Amendments to the Drawings:

REMARKS

FIG. 1

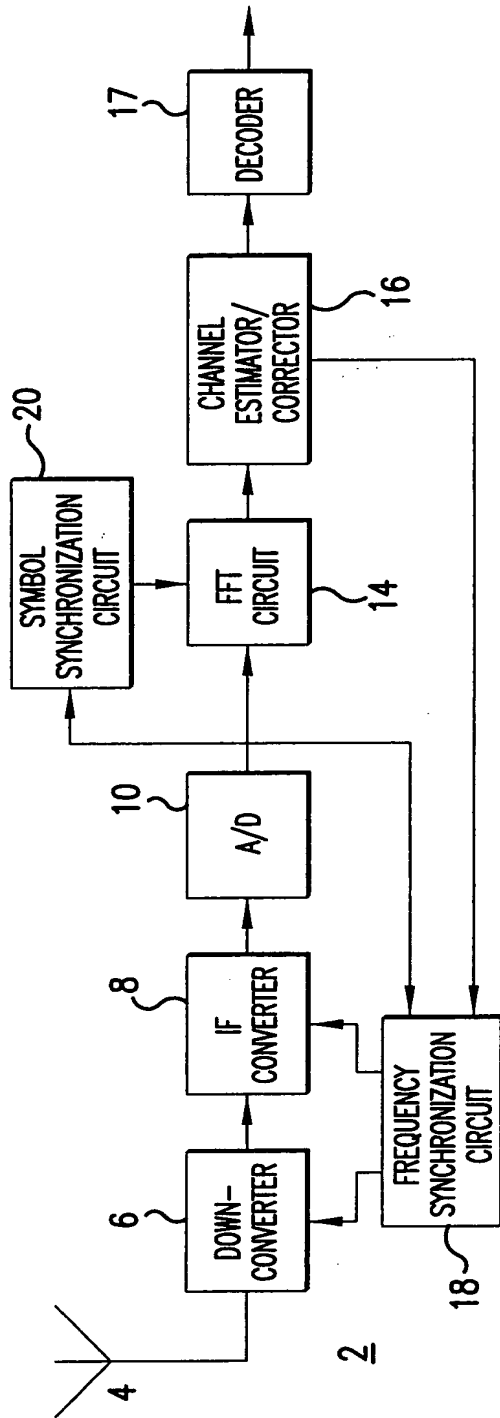
The Office Action states that the demodulating and synchronizing step are not mentioned in the specification. The demodulating step is performed by the apparatus of Figure 1, and the synchronization step by the block 20, as described on page 4, line 15 to page 5, line 12. The Examiner has requested Applicant to label Figure 1 as "prior art". Although the drawing is applicable to the prior art, it is equally applicable to the present

invention if the techniques described with reference to Figure 3 are used in block 20, as specified on page 5, lines 13 to 15.

FIG. 2

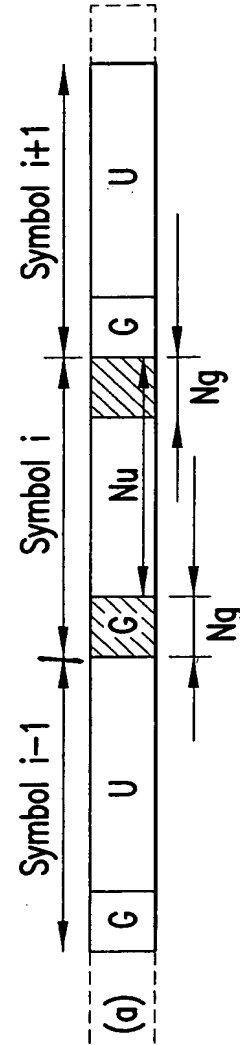
The attached sheets of drawings include changes to Figs. 2 and 3. These sheets, which include Figs. 1-3, replace the original sheets including Figs. 1-3. In Figure 2, a boundary line has been inserted as requested by the Examiner. In Figure 3, a descriptive label for block 24 has been amended to read "DELAY CIRCUIT" and a descriptive label for block 30 has been amended to read "MULTIPLIER". Replacement drawing sheets and annotated drawing sheet are attached. The annotated drawing sheets indicate the changes in red ink.

vertical line

FIG. 3

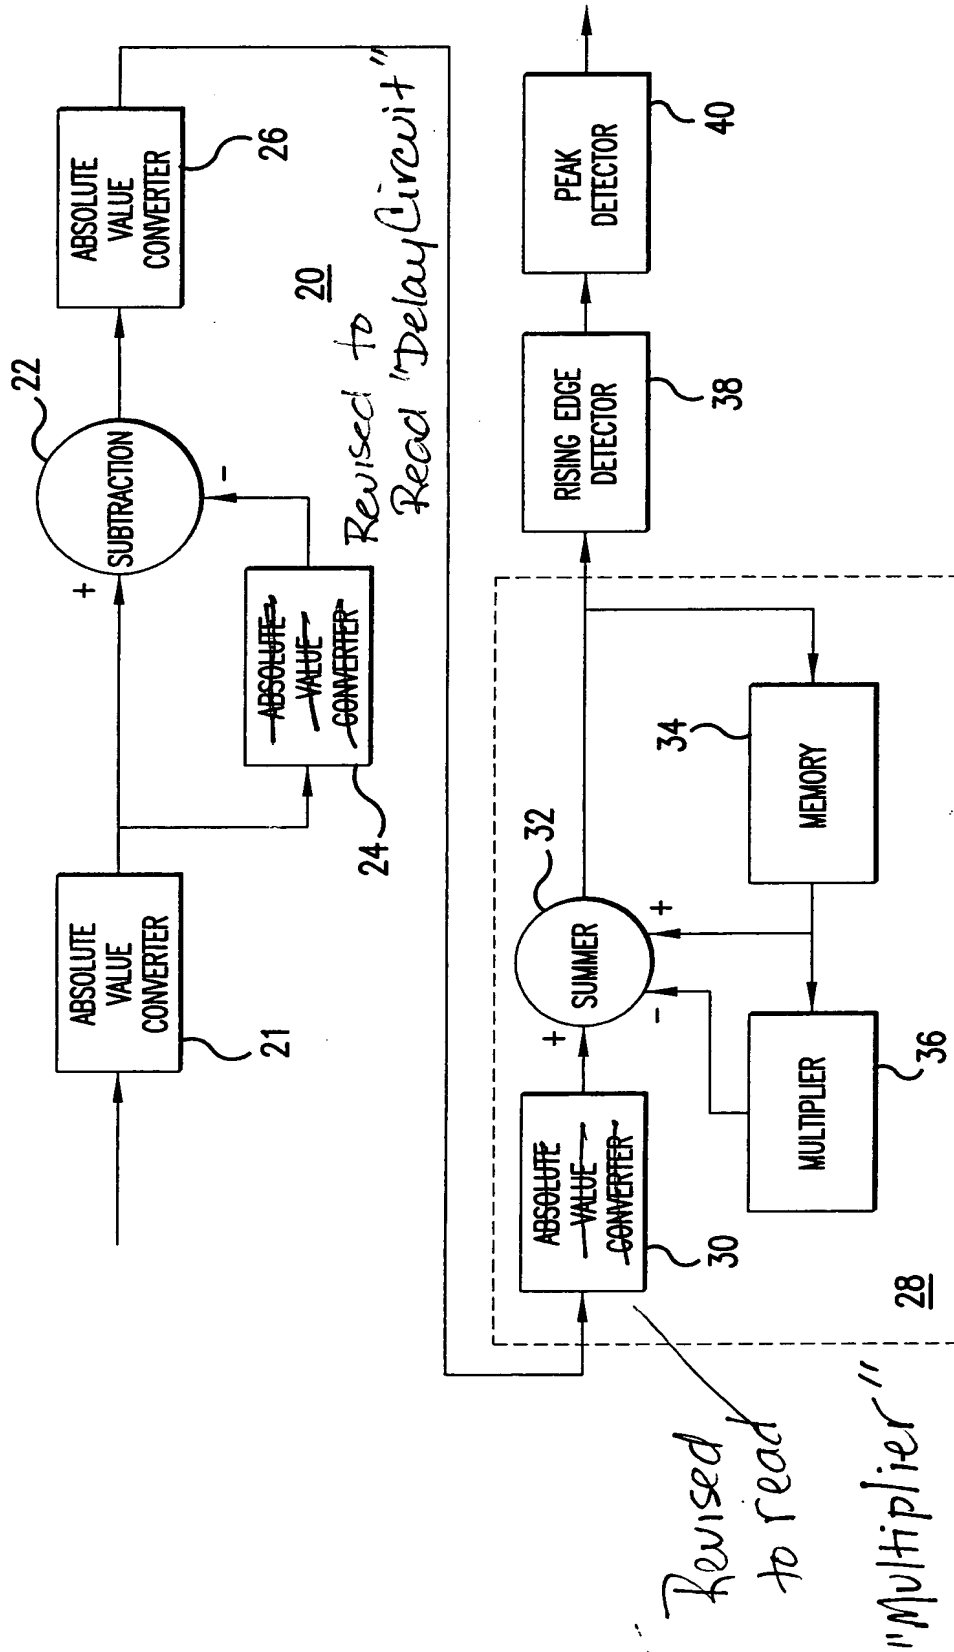
Applicant does not see any inconsistency between the claims and Fig. 3. The difference between the absolute values is provided by subtractor 22 and this is sent (via the absolute converter block 26 and block 28) to the rising edge detector 38, so these components collectively represent "the first circuit for determining and monitoring the difference between the absolute values . . . ". The peak detector 40 is the "second circuit for generating a synchronisation pulse . . . ". The "device" is the receiver of Fig. 1, except for the circuit of Fig. 3 being used for symbol synchronisation circuit 20 (See page 5, lines 13-15).

The Office Action states that, "the specification fails to explain which element(s) of Figure 3 generates the synchronization pulse". The Examiner's attention is kindly directed to page 8, lines 5 to 7, which explicitly states that the "peak detector 40 outputs a logic high signal . . . which is used as the sync pulse."

Claim 3 is objected to for reciting an IIR filter which is allegedly not shown in Figure 3. The Examiner's attention is kindly directed to page 4, lines 1 to 3 which refers to the desirability of using an IIR filter for integrating difference values over a number of symbols; page 6, lines 20 to 22 which refers to this function being formed by the integrating circuit 28; and particularly, page 7, line 13 which specifies the effect of integrating circuit 28 and which one skilled in the art would readily recognize to mean that the integrating circuit 28 is an IIR filter.
